# Turbine layout micro-siting bat specialist comment, and Bat Mitigation Action Plan for inclusion into the updated EMPr

**For the Rietrug Wind Energy Facility (WEF), Northern Cape,  
South Africa**

**05 December 2022**

**Ref: R-2212-54**

**Figure 2.1:** Micro-sited turbine layout in relation to the revised bat sensitivity map. Shaded red = High bat sensitivity; Red line = 200m high bat sensitivity buffer; Shaded yellow = Moderate bat sensitivity; Yellow line = 150m moderate bat sensitivity buffer.

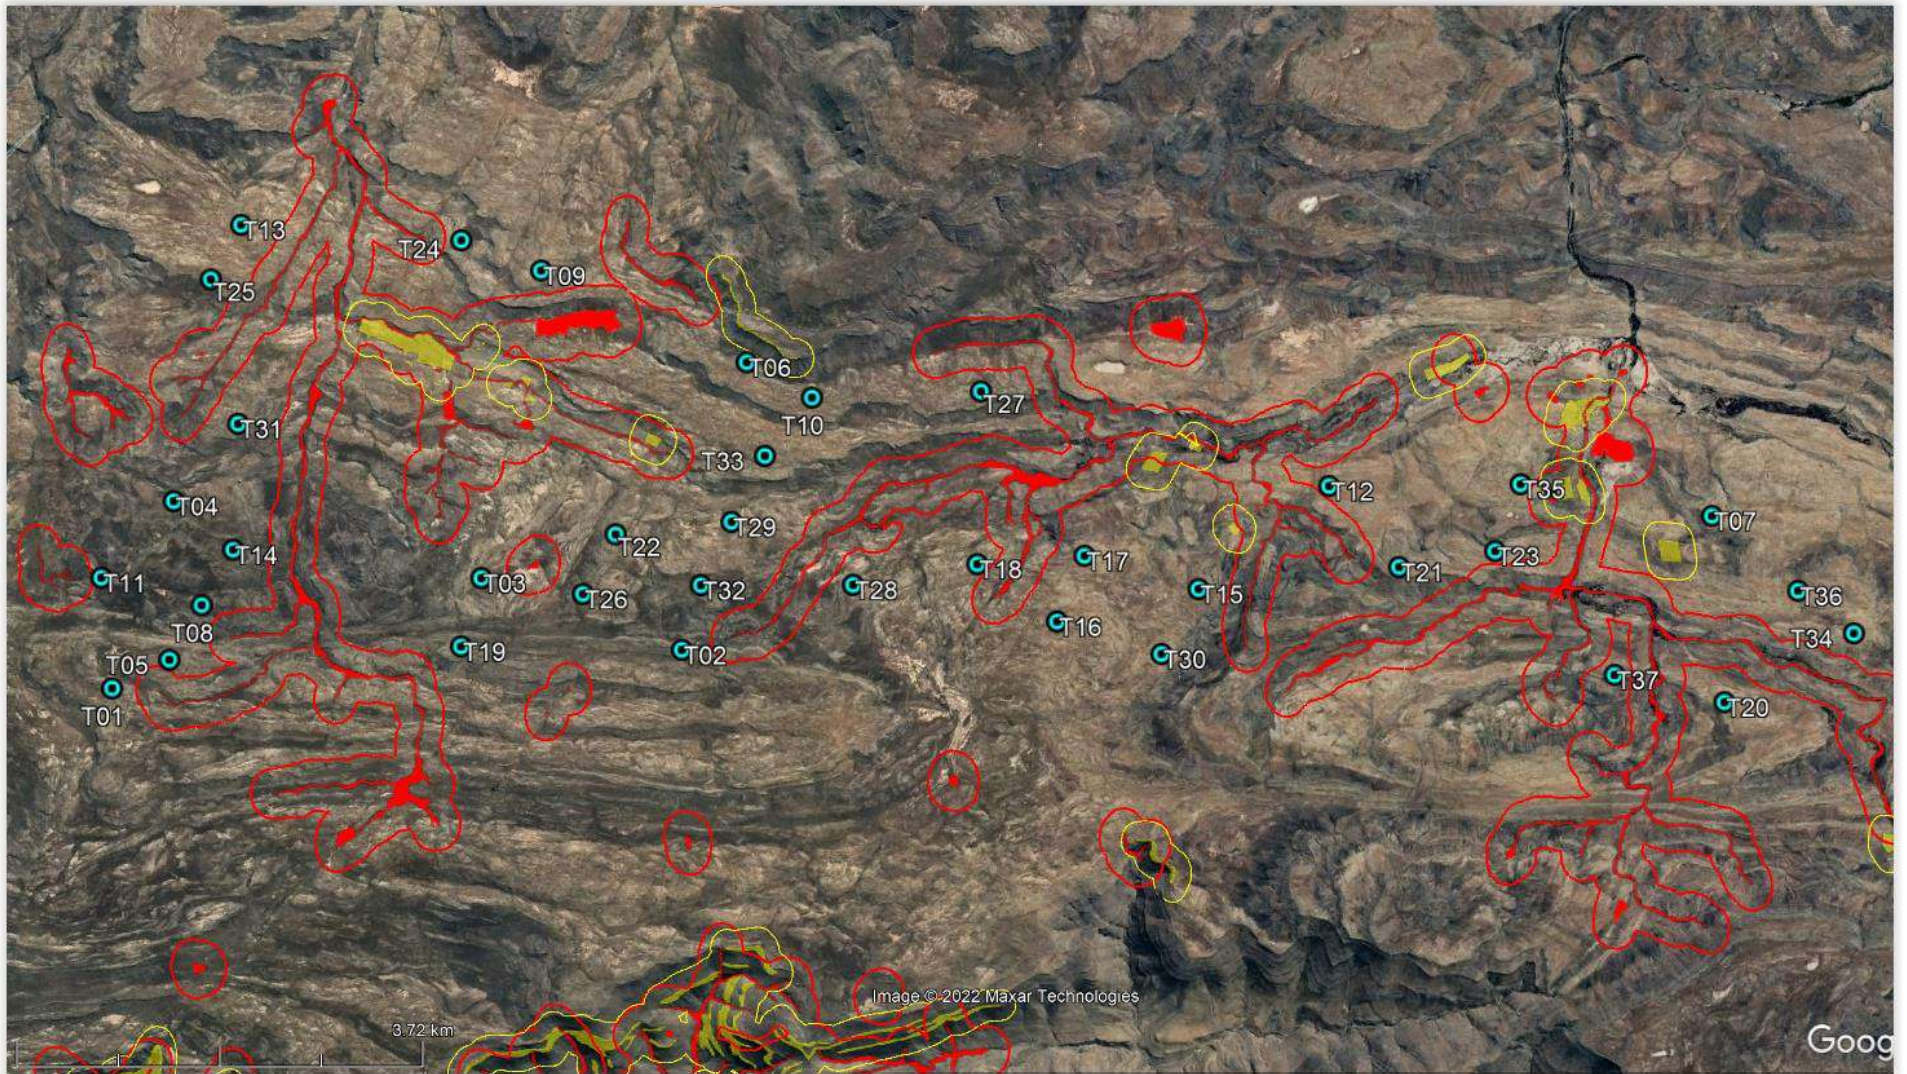
**Tables 2.1 & 2.2** below describes the implications of the sensitivity categories for the different infrastructure types of the WEF. No turbine blades are allowed to intrude into the high bat sensitivity buffer areas, therefore based on a 86m blade length, all turbine bases must be 86m or more from the edge of the 200m high bat sensitivity buffers indicated in **Figure 2.1**.

Based on a rotor diameter of 172m (i.e., 86m blade length), **no turbines or turbine blade overhang are intruding into the high bat sensitivity areas or their buffers.**

**The proposed microsited turbine layout respects the bat sensitivity map, and no turbines blades are intruding into any high bat sensitivities or their associated buffer areas.**

Animalia has **no objection to the proposed microsited final turbine layout**, on condition that this mitigation action plan is incorporated into the EMPr and is adhered to.
